Access Compliance Report

Public Rights-of-Way

Intersection ID: 30281	Main Street: BLYTHEDALE_DR	Cross Street: ELSBERRY_LN	Location: E
ADA ID: D84D096B4FB4	Ramp Type: PerpDiag	Initial Pass/Fail: Fail	Overall Compliance: No
		Severity Score: 25

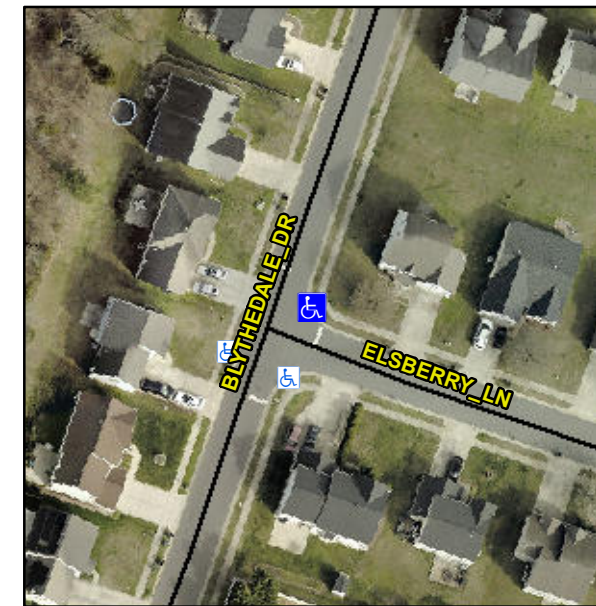
Not Found, R304.5.3

Compliance	Description	Data	Compliance	Description	Data
N/A	Ramp Length (in)	49.0	Yes	Ramp Slope (%)	5.8
Yes	Ramp Width (in)	48.0	No	Ramp XSlope (%)	8.1
N/A	Flare Type LT	N/A	N/A	Flare Type RT	N/A
N/A	Flare Slope LT (%)	N/A	N/A	Flare Slope RT (%)	N/A
N/A	Flare Traversable LT?	N/A	N/A	Flare Traversable RT?	N/A
N/A	Landing Length (in)	N/A	N/A	DWS Provided?	N/A
N/A	Landing Width (in)	N/A	N/A	DWS Contrast?	N/A
N/A	Landing Slope (%)	N/A	N/A	DWS Length (in)	N/A
N/A	Landing X Slope (%)	N/A	N/A	DWS Full Width?	N/A
N/A	Landing Curb? (Y/N)	N/A	N/A	DWS Offset (in)	N/A
N/A	Shared Landing?	N/A			
N/A	Gutter Ponding?	N/A	N/A	Gutter Slope (%)	N/A
N/A	Gutter Lip Ht (in)	1.0	N/A	Gutter X Slope (%)	N/A
N/A	Painted X Walk1?	No	N/A	Painted X Walk2?	No
	X Walk 1 Direction	To N		X Walk 2 Direction	To S
N/A	X Walk 1 Width (in)	N/A	N/A	X Walk 2 Width (in)	N/A
	X Walk 1 Slope (%)	0.3		X Walk 2 Slope (%)	5.3
	X Walk 1 X Slope (%)	5.8		X Walk 2 X Slope (%)	0.5

Remove & Replace Curb Ramp With Two New Directional Ramps or Equivalent.
